# Access Compliance Report

## Public Rights-of-Way

Intersection ID: 12165	Main Street: E_15TH_ST	Cross Street: HARRILL_ST	Location: N
ADA ID: A413011CA3CB	Ramp Type: BlendTrans2	Initial Pass/Fail: Pass	Overall Compliance: No
Severity Score: 20.25			
Codes/Mitigation Info/Possible Solution		Field Measurements/Component Compliance

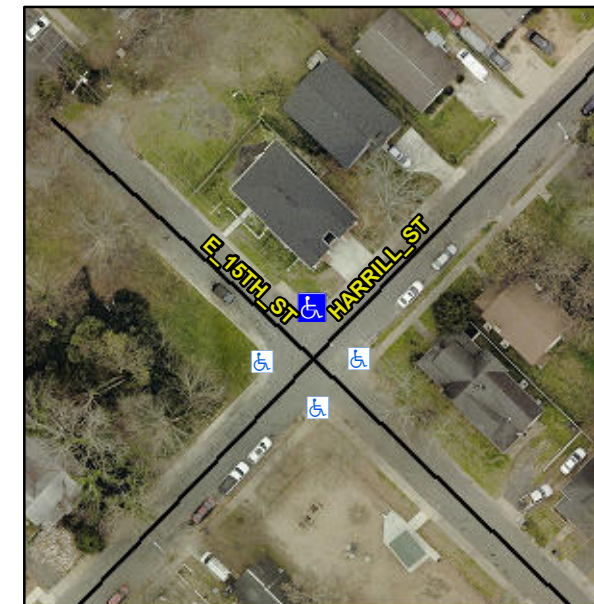
**NO CURB LINE**

**R304.5.3, R304.2.3, R305, R302.7.2**

Compliance	Description	Data	Compliance	Description	Data
N/A	Ramp Length (in)	62.0	Yes	BlendTrans Slope (%)	2.4
Yes	Ramp Width (in)	48.0	No	BlendTrans XSlope (%)	2.5
N/A	Flare Type LT	Sloped	N/A	Flare Type RT	Sloped
No	Flare Slope LT (%)	10.7	Yes	Flare Slope RT (%)	0.7
N/A	Flare Traversable LT?	Yes	N/A	Flare Traversable RT?	Yes
N/A	Landing Length (in)	N/A	No	DWS Provided?	No
N/A	Landing Width (in)	N/A	N/A	DWS Contrast?	No
N/A	Landing Slope (%)	N/A	N/A	DWS Length (in)	N/A
N/A	Landing X Slope (%)	N/A	N/A	DWS Full Width?	No
N/A	Landing Curb? (Y/N)	No	N/A	DWS Offset (in)	N/A
N/A	Shared Landing?	No			
Yes	Gutter Ponding?	No	Yes	Gutter Slope (%)	4.1
No	Gutter Lip Ht (in)	0.5	No	Gutter X Slope (%)	4.6
N/A	Painted X Walk1?	No	N/A	Painted X Walk2?	No
	X Walk 1 Direction	To SW		X Walk 2 Direction	To SE
	X Walk 1 Width (in)	N/A		X Walk 2 Width (in)	N/A
	X Walk 1 Slope (%)	3.0		X Walk 2 Slope (%)	1.9
	X Walk 1 X Slope (%)	4.2		X Walk 2 X Slope (%)	1.3

**Remove & Replace Curb Ramp With Two New Directional Ramps or Equivalent. Remove & Replace Gutter.**
